MECKLENBURG COUNTY HEALTH DEPARTMENT

APPLICATION FOR PERCOLATION TEST

5) SUBDIVISION APPLE CREEK LOT NO. 27 BLOCK NO. D

SITE INVESTIGATION REPORT
INDIVIDUAL SEPTIC TANK SYSTEM
WITH SUBSURFACE,
SOIL ABSORPTION,
EFFLUENT DISCHARGE

DIAGRAM OF PROPERTY

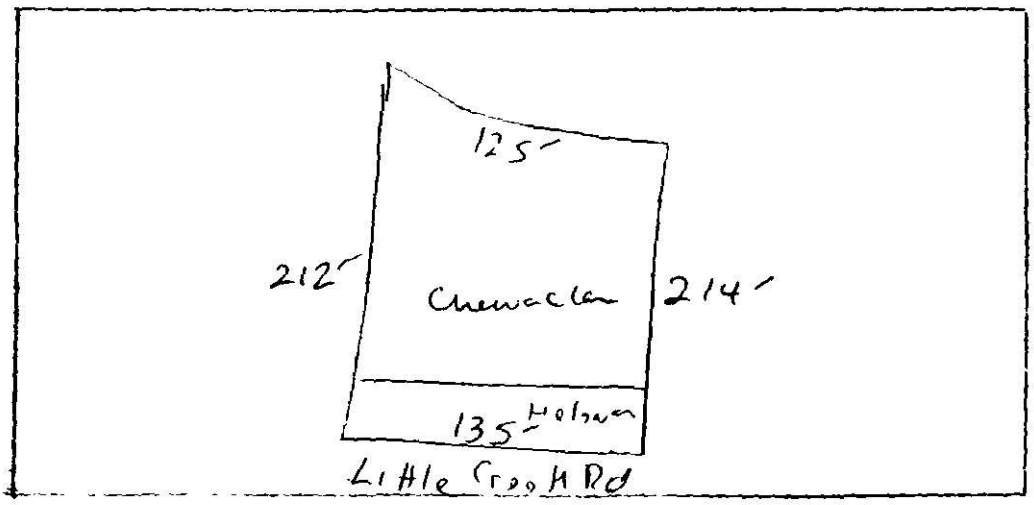
Recommendations Based on this investigation, the lot was found to have soils dominantly unsuitable for installation of a septic tank system.

See diagram on back
